Access Compliance Report

Public Rights-of-Way

(Curb Ramps)

Intersection ID: 13133	Main Street: S_CALDWELL_ST	Cross Street: E_STONEWALL_ST	Location: SE
ADA ID: F7C1CAD621F9	Ramp Type: Perp	Initial Pass/Fail: Fail	Overall Compliance: No
Severity Score: 25			
Codes/Mitigation Info/Possible Solution		Field Measurements/Component Compliance

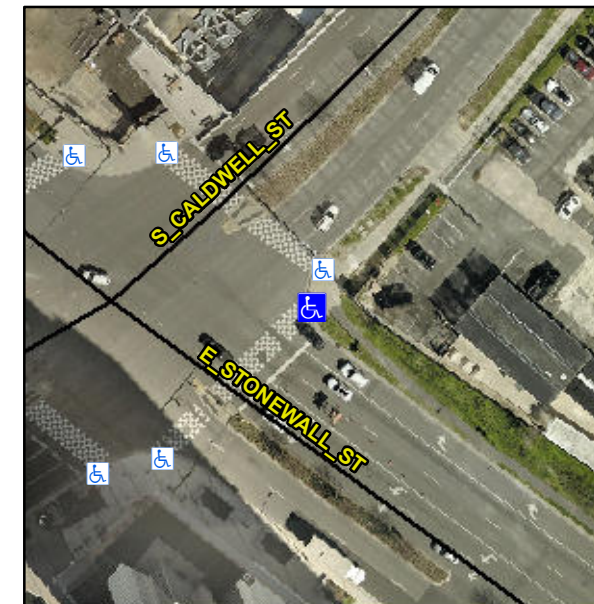
Not Found, R304.5.3

Compliance	Description	Data	Compliance	Description	Data
N/A	Ramp Length (in)	95.0	Yes	Ramp Slope (%)	6.7
Yes	Ramp Width (in)	72.0	No	Ramp XSlope (%)	7.4
N/A	Flare Type LT	N/A	N/A	Flare Type RT	N/A
N/A	Flare Slope LT (%)	N/A	N/A	Flare Slope RT (%)	N/A
N/A	Flare Traversable LT?	N/A	N/A	Flare Traversable RT?	N/A
N/A	Landing Length (in)	N/A	N/A	DWS Provided?	N/A
N/A	Landing Width (in)	N/A	N/A	DWS Contrast?	N/A
N/A	Landing Slope (%)	N/A	N/A	DWS Length (in)	N/A
N/A	Landing X Slope (%)	N/A	N/A	DWS Full Width?	N/A
N/A	Landing Curb? (Y/N)	N/A	N/A	DWS Offset (in)	N/A
N/A	Shared Landing?	N/A			
N/A	Gutter Ponding?	N/A	N/A	Gutter Slope (%)	N/A
N/A	Gutter Lip Ht (in)	N/A	N/A	Gutter X Slope (%)	N/A
N/A	Painted X Walk1?	Yes	N/A	Painted X Walk2?	N/A
	X Walk 1 Direction	To SW		X Walk 2 Direction	N/A
N/A	X Walk 1 Width (in)	144.0	N/A	X Walk 2 Width (in)	N/A
	X Walk 1 Slope (%)	1.4		X Walk 2 Slope (%)	N/A
	X Walk 1 X Slope (%)	7.9		X Walk 2 X Slope (%)	N/A

Remove & Replace Entire Ramp.
